ENVIRONMENTAL SURVEY

CAPCO - Ragland Plant

AMERICAN SMELTING AND REFINING COMPANY
Department of Environmental Sciences
Salt Lake City, Utah

Report Date: January 20, 1975

SMALL COUPLING LATHE

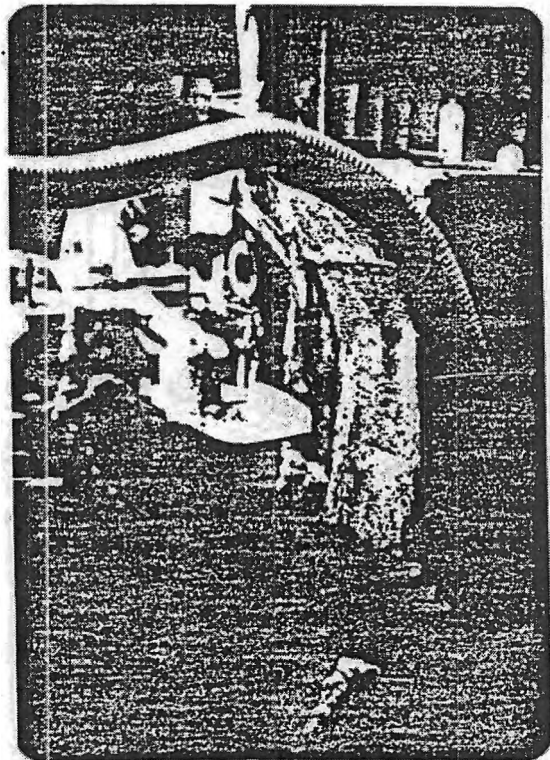
Dry couplings are being cut, and ventilation system is not picking up all of the dust produced. Floor around operator is covered with asbestos waste.

SMALL COUPLING LATHE

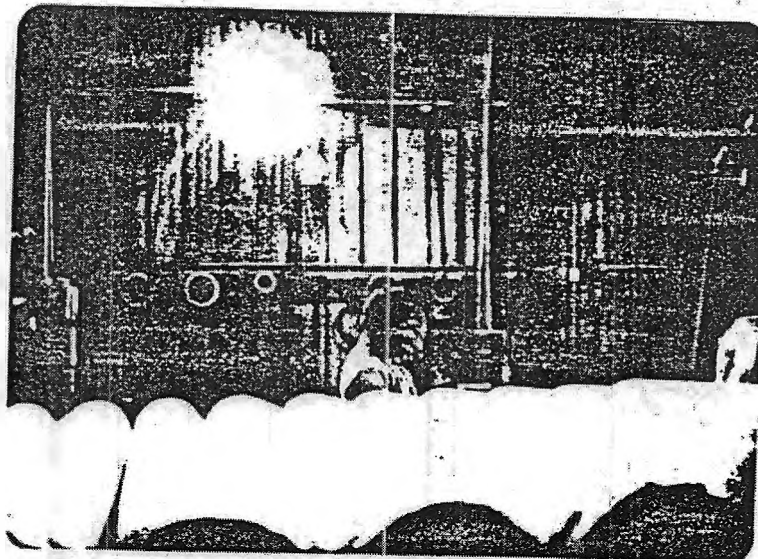
Better housekeeping to prevent accumulations of asbestos waste, as shown on the machine and floor, is needed.

FLEXTESTER

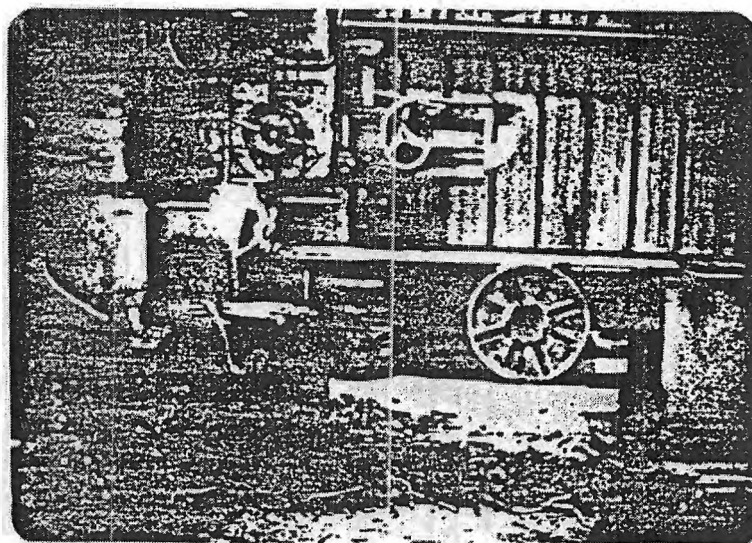
The employee is using a hand-grinder which is not ventilated.

SHOP AREA

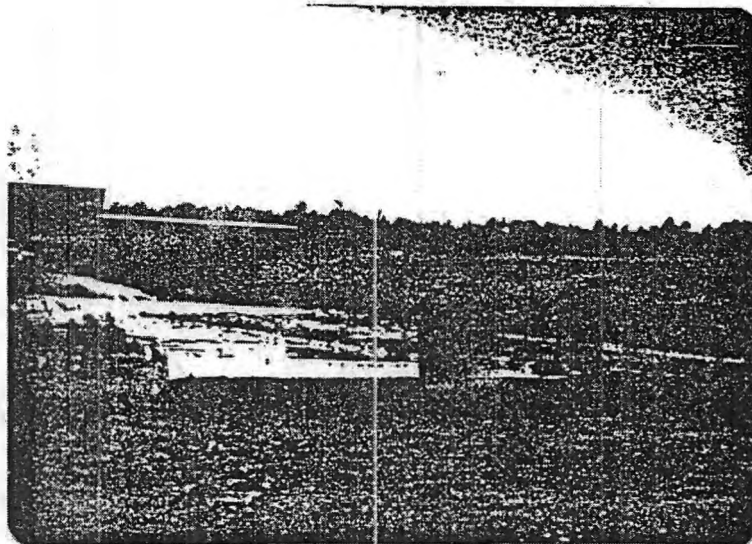
Housekeeping around the shops should be improved.

SOLID WASTE DUMP

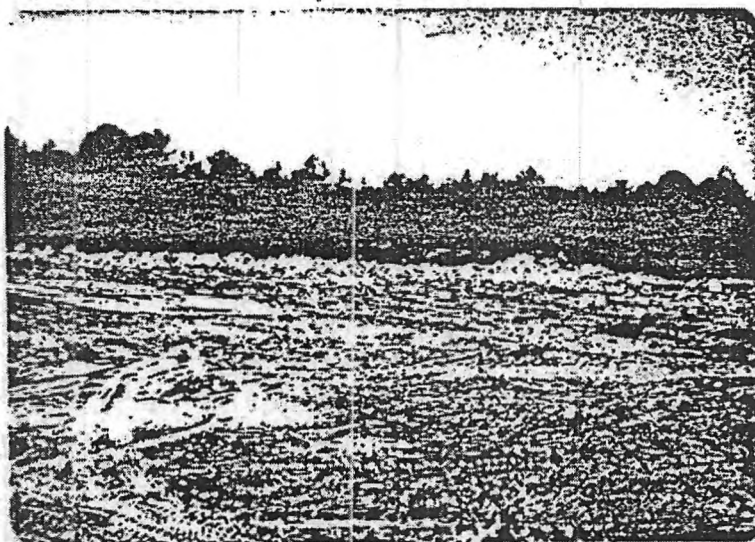
File of loose asbestos waste
is near center of picture.

The dump should be converted
to a sanitary landfill. A
State permit may be needed.
